CD# 00216-CORR-00521-00014

**Deep Geologic Repository for Low and Intermediate Level Radioactive Waste Project
– Response to Information Request Package**

**Response to Information Request Package of April 5, 2017 from
the Canadian Environmental Assessment Agency**

Figure 1. Timelines of the DGR Project at the Bruce Nuclear site and the APM DGR Project

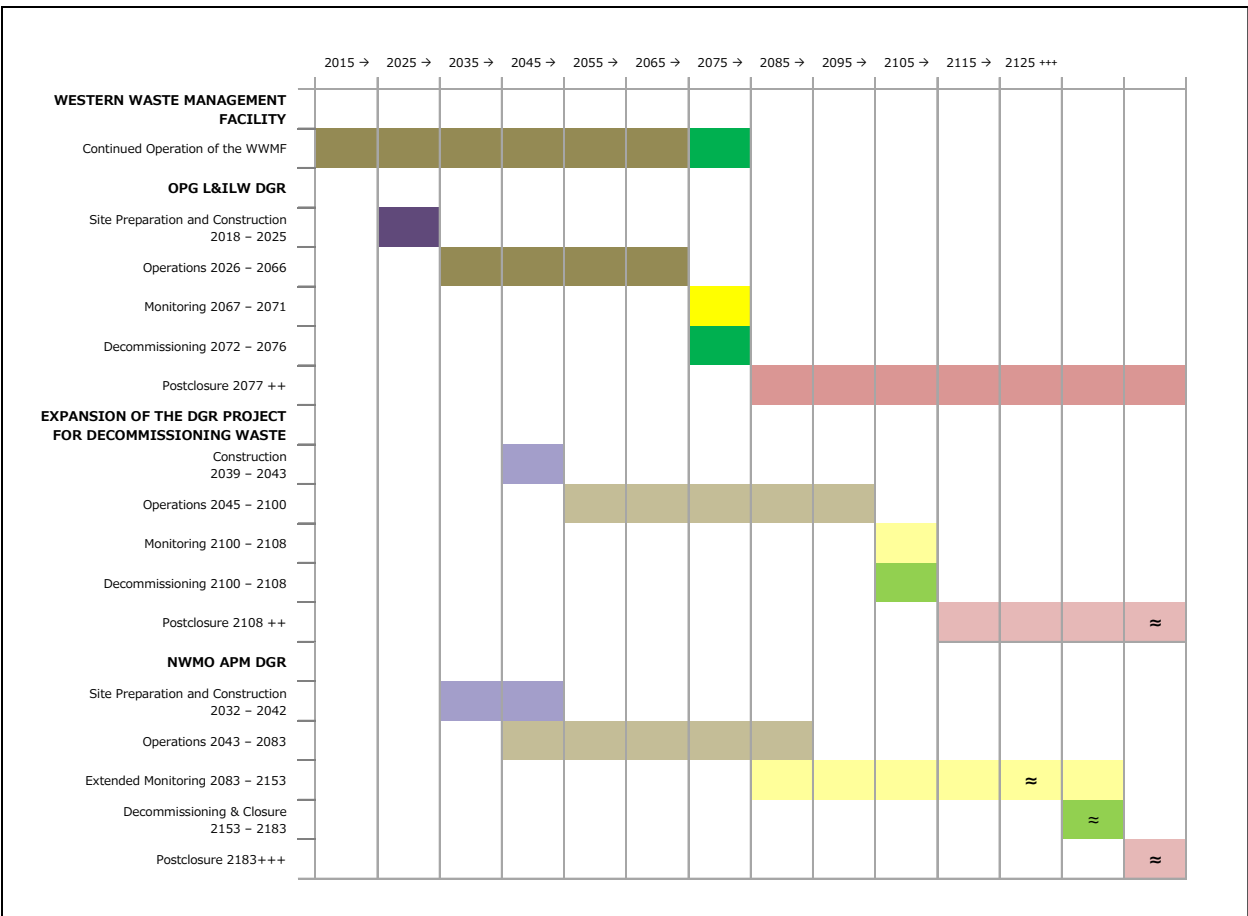
IR #	IR Title	Information Request and Response
IR-2.1	Methodology for Temporal Boundaries	<p>Information Request:</p> <p><i>Provide a description of the variability in the timelines (upper and lower estimates) during all phases of the Project.</i></p> <ul style="list-style-type: none"> • <i>Based on that variability, identify the activities that have the potential to overlap with the APM DGR project, and the potential cumulative effect on VCs, and;</i> • <i>Where the site preparation and construction activities of the Project overlap in time with the APM DGR project, the Western Waste Management Facility or the Project’s expansion at the Bruce site, provide a description of the potential cumulative effects to all VCs, including air quality.</i> <p>Rationale:</p> <p><i>Figure 2-2 on page 7 of the “Updated Analysis Cumulative Environmental Effects” report provides timelines for the Project at the Bruce Site and the Adaptive Phased Management (APM) DGR project for the disposal of used nuclear fuel. Given that the Project is in the engineering designing phase and the APM DGR project is in the pre-feasibility stage, there could be a large degree of overlap and variability in the timelines for each project. For example, OPG’s analysis found that there is a potential for geographic overlap of effects between the Project and the APM DGR project. However, OPG states that it is likely that activities that generate air emissions associated with each project will occur at the exact same time due to the anticipated infrequent nature of air emissions across the phases of the projects. OPG further states that it is also unlikely that the air emissions will persist in the atmosphere for the same duration and therefore concludes no residual adverse cumulative effect on air quality.</i></p> <p><i>In order to better predict the range of potential cumulative environmental effects of both projects, there must be an understanding of the variability for the project timelines and where there could be additional overlapping activities.</i></p> <p>OPG Response:</p> <p>The assessment of cumulative effects conducted in the Updated Analysis Cumulative Environmental Effects report [GOLDER 2016] considered the potential for cumulative effects between the construction, operation, monitoring and decommissioning phases of the OPG DGR and a potential future APM DGR in the communities shown on Figure 4-1 of GOLDER [2016] (i.e., the Township of Huron-Kinloss, Municipality of South Bruce, or Municipality of Central Huron). As shown on Figure 1, the site preparation and construction phases of the two projects are likely to occur at different times, involving little to no overlap, while operations would overlap for about 30 years.</p> <p>Since there is a substantial degree of potential variability in the timelines for both of these projects, when the specific upper and lower estimates will begin or end cannot be identified with confidence. However, the assessment of cumulative effects took this variability into account. Figure 1 shows the earliest reasonably achievable start dates for each project, and the longest predicted duration for each phase. The start dates for either or both projects may be delayed, depending on the timing required for each of the phases, and some of the phases may overlap more or less</p>

IR #	IR Title	Information Request and Response
		<p>through time. To conservatively address all of the described variability in the analysis of potential cumulative effects, it was assumed that all of the effects would overlap temporally for all of the Valued Components (VCs) (as summarized in Table 7-1 of [GOLDER 2016]). Of course, this approach provides the worst case scenario and would likely overestimate the potential cumulative effects.</p>  <p>WESTERN WASTE MANAGEMENT FACILITY</p> <ul style="list-style-type: none"> Continued Operation of the WWMF: 2015 → 2075 (olive green), 2075 → 2085 (green) <p>OPG L&ILW DGR</p> <ul style="list-style-type: none"> Site Preparation and Construction 2018 – 2025: 2018 → 2025 (purple) Operations 2026 – 2066: 2026 → 2066 (olive green) Monitoring 2067 – 2071: 2067 → 2071 (yellow) Decommissioning 2072 – 2076: 2072 → 2076 (green) Postclosure 2077 ++: 2077 → 2125 (red) <p>EXPANSION OF THE DGR PROJECT FOR DECOMMISSIONING WASTE</p> <ul style="list-style-type: none"> Construction 2039 – 2043: 2039 → 2043 (purple) Operations 2045 – 2100: 2045 → 2100 (olive green) Monitoring 2100 – 2108: 2100 → 2108 (yellow) Decommissioning 2100 – 2108: 2100 → 2108 (green) Postclosure 2108 ++: 2108 → 2125 (red) <p>NWMO APM DGR</p> <ul style="list-style-type: none"> Site Preparation and Construction 2032 – 2042: 2032 → 2042 (purple) Operations 2043 – 2083: 2043 → 2083 (olive green) Extended Monitoring 2083 – 2153: 2083 → 2153 (yellow) Decommissioning & Closure 2153 – 2183: 2153 → 2183 (green) Postclosure 2183+++ : 2183 → 2125 (red)

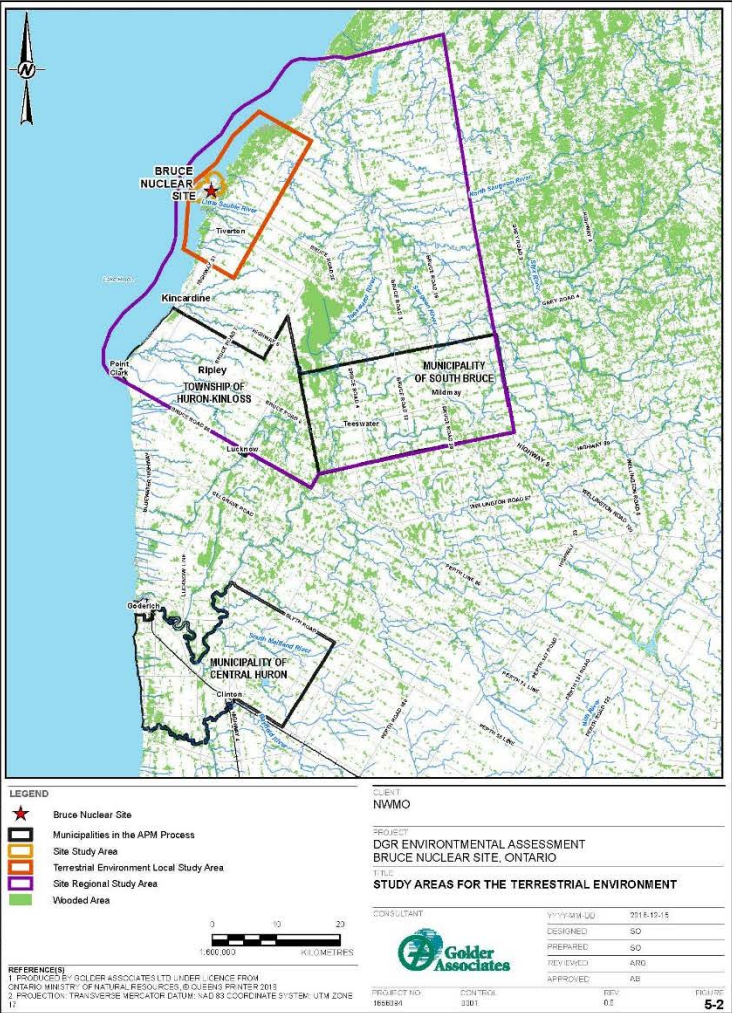
IR-2.4	Radiation, Radioactivity and Groundwater Monitoring	<p>Information Request:</p> <ul style="list-style-type: none"> • Discuss measures that are available for identifying and monitoring potential effects on groundwater quality from post-closure migration of radionuclides. • Provide a narrative discussion of the potential cumulative effects from the APM DGR project and the Project on appropriate non-human biota VCs.

IR #	IR Title	Information Request and Response
		<p>Rationale:</p> <p><i>The updated assessment of cumulative environmental effects is limited to those VCs for which residual adverse environmental effects from the Project are predicted. The “Updated Analysis Cumulative Environmental Effects” report describes the potential adverse effects resulting from the APM DGR project in one of the nearby host communities. Within section 5.8.1 of the report, OPG states that during all phases of the Project, the APM DGR project has the potential for radiological emissions. These radiological emissions from the APM DGR project may have additive radiation effects on the emissions resulting from the Project at the Bruce site.</i></p> <p><i>When effects of the two projects overlap in time and in space there is potential for cumulative environmental effects. These effects are assessed and mitigation measures are identified in the “Updated Analysis Cumulative Environmental Effects” report; however, the report concludes that any cumulative adverse environmental effects related to post-closure migration of radionuclides in deep groundwater systems would be unlikely. The report also identifies a potential for adverse cumulative environmental effects for the environment components of radiation and radioactivity related to deep ground water systems. Specifically, radionuclide diffusion from the two repositories could eventually reach more active ground water systems in the Cambrian sandstone and Guelph Formation, which are connected across the region. The consequences of such movement could have potentially adverse effects. Taking this into consideration, it is unclear why VCs directly related to geology and hydrogeology were not assessed further in the cumulative environmental effects assessment.</i></p> <p><i>Further, an assessment of the ecological risk due to C-14 and H-3 on a number of terrestrial species with large habitat ranges, including mammals, such as white tailed deer and resident bird species such as wild turkey, was not conducted.</i></p> <p>OPG Response:</p> <p><u>Postclosure Migration</u></p> <p>The rationale for this question refers to the potential for postclosure radionuclide diffusion from the two repositories (i.e., the OPG DGR at the Bruce Nuclear site and an APM DGR assuming that it is sited in the region) to reach the Cambrian sandstones or the Guelph Formation. These are the closest permeable rock formations below and above the repositories. They extend across the region, and therefore could provide a path for interaction between the repositories.</p> <p>The Cambrian sandstone and the Guelph formations represent deep-seated confined saline aquifers. Beneath the Bruce Nuclear site, these thin confined aquifers are vertically separated by 430 m of low permeability shales and carbonates of upper Ordovician to lower Silurian age. The groundwater in the aquifers is non-potable and there is no evidence of mixing with surface glacial origin meltwaters. The Cambrian formation is not laterally continuous and likely does not lie beneath the APM DGR siting areas that are tens of kilometres inland of Lake Huron. This situation, coupled with the repositories being positioned in the Cobourg Formation with vertical separation to the saline aquifers by diffusion dominated aquitard/aquiclude systems exceeding 150 m in thickness, strongly indicates radionuclide</p>

IR #	IR Title	Information Request and Response
		<p>release would occur over extremely long time periods. Peak release to the Cambrian formation from the OPG DGR described in OPG’s response to Information Request EIS-04-129 [OPG 2012] was on the order of 1.5 Ma and 100 times less than the regulatory criteria. At nearest, an APM repository would be 20 km from the Bruce Nuclear site repository. This physical separation and hydrogeological isolation within a stable ancient diffusion dominated groundwater domain suggests that material cumulative effects or interaction within these sub-surface pathways is highly unlikely.</p> <p>Cumulative radiological effects could only potentially occur in the non-credible (i.e., “what if”) event of failure of multiple barriers at both the OPG DGR and APM DGR sites that would be 20 to 90 km apart. Both repositories are to be sited and engineered to withstand the effects of future glaciations and earthquakes [NWMO 2013].</p> <p><u>Monitoring Potential Effects on Groundwater</u></p> <p>There are a number of measures available for monitoring and identifying potential effects on groundwater quality from postclosure migration of radionuclides. These are discussed below.</p> <p>Postclosure monitoring activities would be informed by more than 50 years of environmental monitoring conducted within the DGR and in the surrounding vicinity. This monitoring performed during the site preparation and construction, operation and decommissioning phases of the OPG DGR would allow verification of predictions regarding potential environmental effects and, if required, the effectiveness of mitigation measures. Proposed monitoring measures will include formation pressure profiles within different aquifer systems, along with groundwater sampling and analysis for major ions, general chemistry (e.g., pH, Eh, temperature, electrical conductivity), radionuclides, trace elements, and petroleum hydrocarbons. The proposed monitoring measures will verify isolation of the waste from the surrounding environment.</p> <p>The OPG DGR is designed to be passively safe after closure. Confidence in postclosure DGR performance is gained, in part, from the regulatory reported environmental monitoring program described above. Postclosure monitoring would be performed in a manner that does not influence the repositories’ passive safety. The nature and duration of postclosure monitoring will be decided in the future with the regulator and will likely include parameters similar to those proposed for the earlier stages of the project such that unexpected conditions associated with repository re-saturation and/or contaminant release could be detected.</p> <p>The APM DGR would also be subject to similar postclosure monitoring [NWMO 2016]. These programs would be established as part of the applicable regulatory process in advance of decommissioning.</p> <p><u>Cumulative Effects on Non-human Biota</u></p> <p>Aquatic and terrestrial biota receive radiation doses from exposure to radioactivity in the atmosphere, surface water and from other media into which it transfers. The effects of the OPG DGR and APM DGR projects arising from radiological emissions would be a small increment to the baseline concentrations around each of the respective sites.</p>

Figure 5-2 (associated with IR-2.5 response). Study Areas for the Terrestrial Environment.

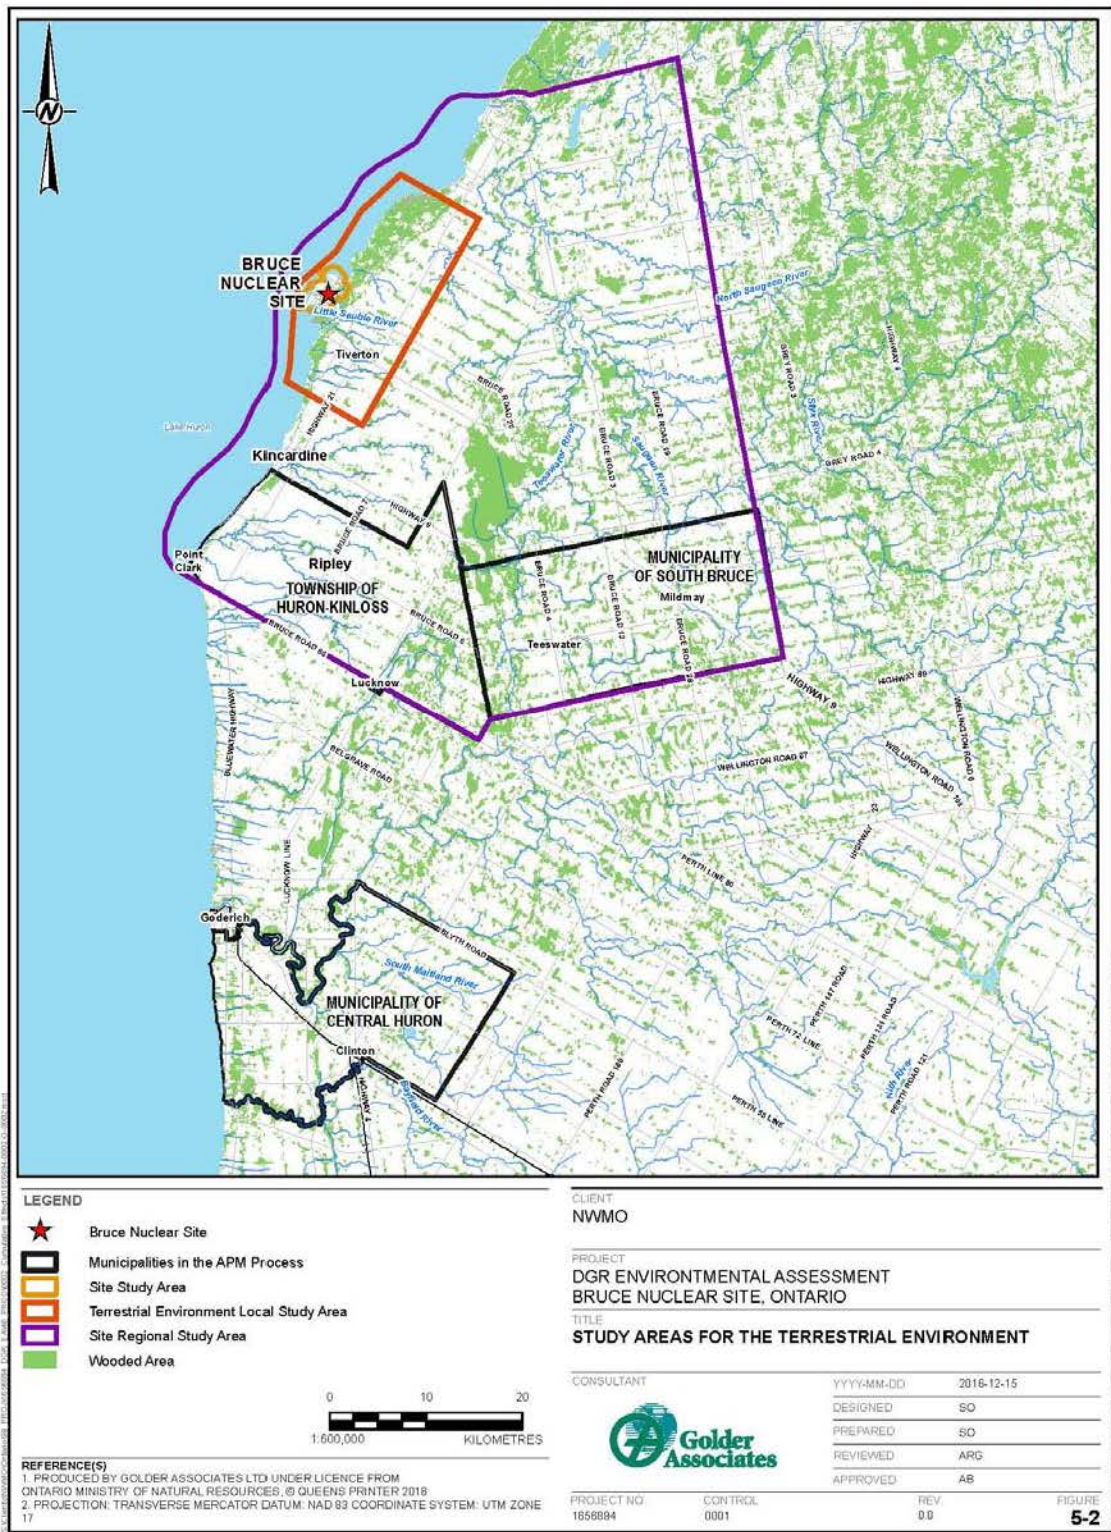
IR-2.5	Species at Risk	<p>Information Request:</p> <p><i>Provide an assessment of the potential cumulative environmental effects on the terrestrial environment that includes impacts on wetlands and species at risk, specifically the Snapping Turtle, Eastern Ribbonsnake and Eastern Milksnake.</i></p> <p>Rationale:</p> <p><i>As part of the site preparation and construction activities of the Project, wetland 3 would be infilled. Snapping Turtles have been observed in this wetland, and Environment and Climate Change Canada (ECCC) advised that it could be possible for Eastern Ribbonsnake and Eastern Milksnake individuals to move into the Bruce DGR site. These potential residual effects from the Project were not assessed in combination with the potential effects from the three proposed APM DGR sites.</i></p>

IR #	IR Title	Information Request and Response
		<p>The cumulative effects assessment for the DGR Project at the Bruce Nuclear site terrestrial environment [OPG 2011] used the Site Study Area to determine the potential for the Project to interact cumulatively with other projects and activities on VCs, since the residual adverse effect of the DGR Project at the Bruce Nuclear site on the terrestrial environment (specifically the eastern white cedar VC) is restricted to the Site Study Area (Figure 5-2). Because snapping turtle, eastern ribbonsnake and milksnake are mobile and will move in and out of the Site Study Area and potential direct effects (i.e., removal of potential suitable habitat) are limited to the Site Study Area, it is appropriate to consider the Terrestrial Environment LSA as the range of movement for local populations of these species and for the assessment of potential residual effects of the DGR on these species. In addition, the effects assessment inherently gives consideration to combined effects of other regional land uses or sources of stress on VCs. No future land uses were identified at a scale that cumulatively would involve removal of plant and wetland communities and compromise the sustainability of snapping turtle, eastern ribbonsnake or milksnake.</p> <p>There is more abundant and well distributed quality habitat for snapping turtle, eastern ribbonsnake and milksnake outside of the Site Study Area in the Terrestrial Environment LSA (Figure 5-2). As a result, it is predicted that the small measurable loss of Wetland 3 and other terrestrial vegetation communities as a result of the DGR Project at the Bruce Nuclear site relative to similar habitat available in the Terrestrial Environment LSA would likely have no significant residual adverse effect on these VCs.</p> <p><u>Assessment of Cumulative Effects at the APM DGR</u></p> <p>The APM DGR site selection will consider environmental constraints such as the need for clearing vegetation and effects to wetland communities for the construction of surface facilities. It is expected that key habitats (hibernation and gestation/nesting habitats) identified during baseline data collection for Species at Risk such as snapping turtle, eastern ribbonsnake and milksnake could be avoided by the siting of infrastructure away from these features. Direct physical changes from the APM DGR footprint to these key features would be avoided or minimized.</p> <p>Additional direct impacts to these species from the construction and operation phases may include an increased risk of injury or mortality from interactions with vehicle traffic and heavy equipment. These risks can be mitigated and likely eliminated by the implementation of measures, such as reptile exclusion fencing around the active construction site. Additionally, if heavy traffic volumes are anticipated on the access roadways, exclusion fencing could be erected along identified potential movement corridors along the roadway to convey snakes and turtles through culvert crossings.</p> <p>Potential residual adverse effects from the APM DGR have been identified on terrestrial habitat and biota during all project phases of the APM DGR [NWMO 2014, NWMO 2015]. The APM DGR would involve vegetation clearing for site access, and for the construction of surface facilities and a waste rock management area. It is anticipated that surface facilities, waste rock management and the ventilation exhaust shaft would require a maximum land clearing of up to 60 ha. These activities will contribute to a long-term loss of terrestrial vegetation, which may include wetland communities and potential habitats for snapping turtle, eastern ribbonsnake and milksnake. The APM DGR is likely to overlap in time with potential effects of the DGR Project at the Bruce Nuclear site on snapping turtle, eastern</p>
